SUBJECT Transportation Protective Sleeve Introduced for Windshield Wipers

MODEL R55 (Cooper Clubman)

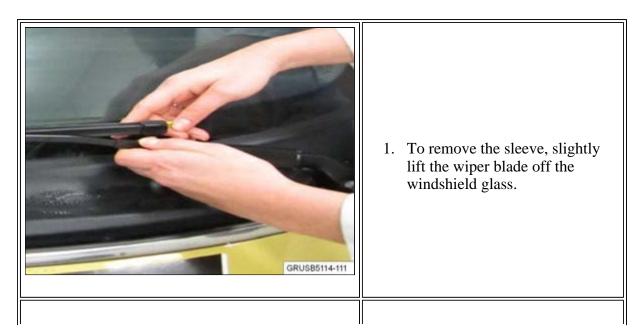
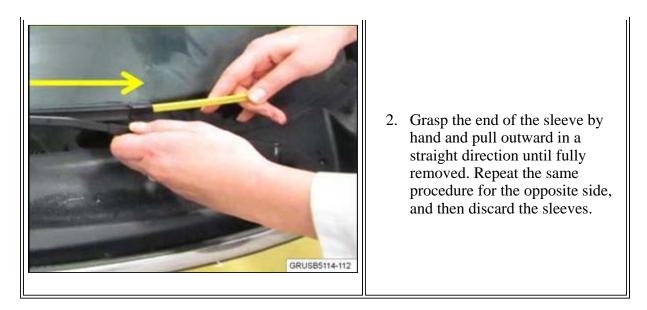
The windshield wipers streak and judder.

The windshield wiper blades become distorted during transportation and when in storage.

The factory has been installing windshield wiper protective sleeves since March 13, 2014.

The transportation protective sleeves are intended to protect the windshield wiper blades when vehicles are being transported and stored. Therefore, please do not remove them until the final detail inspection and delivery to the customer.

However, for proper wiper operation and so that the customer is satisfied when his or her new car is delivered, please remove the protective sleeves prior to delivery.

Note: Do not use any tools. Always slide the sleeve by hand outwards in a straight line. Do not bend the wiper blade or sleeve.
